TECHNICAL BULLETIN	
	August 2003
	TB 1952R
Mfg:	GM
Model:	PONTIAC
Liter:	3.8L
V I N:	K
Year:	95-06

Updated Cylinder Head Installation Procedure For
1995-2002 GM 3.8L VIN 1 & K Engines

Bulletin Diagram: FIGURE 1, CYLINDER HEAD TORQUE SEQUENCE. - CYLINDER HEAD

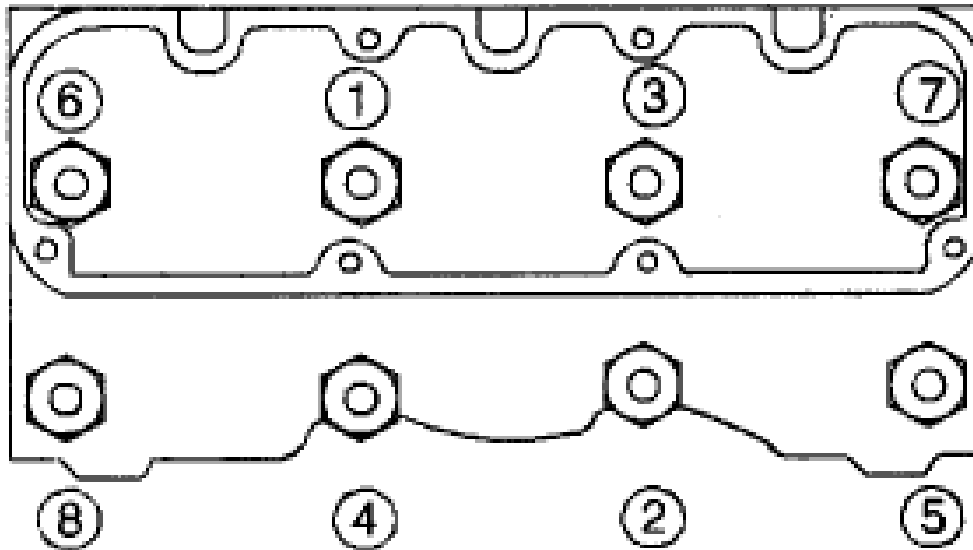
The AERA Technical Committee offers the following information regarding cylinder head installation for 1995-2002 GM 3.8L VIN 1 & K engines. This bulletin should be used and AERA TB 1952 should be discarded. Various other published service information has been incomplete and this bulletin provides the most up to date information.

The cylinder head bolts used for these engines were designed for a one time use and should be replaced anytime the heads are re-installed. Failure to replace the bolts during head installation will yield an improper assembled torque.

1. Thoroughly clean the threads in the block using a 7/16–14 tap.
2. Install the head gasket with the arrow pointing to the front of the engine.
Figure 1. Cylinder Head Torque Sequence
3. Install the new cylinder head bolts dry. NOTICE: This bolt is designed to permanently stretch when tightened. The correct part number fastener must be used to replace this type of fastener. Do not use a bolt that is stronger in this application. If the correct bolt is not used, the parts will not be tightened correctly. The system or the components may be damaged.
Step 1. Tighten all bolts in sequence to 35-37 ft/lbs (49-50 Nm).
Step 2. Rotate each bolt 130° in sequence. Use the J36660.
Step 3. Rotate the center four bolts 1,2, 3 & 4 an additional 30°. Use the J36660.
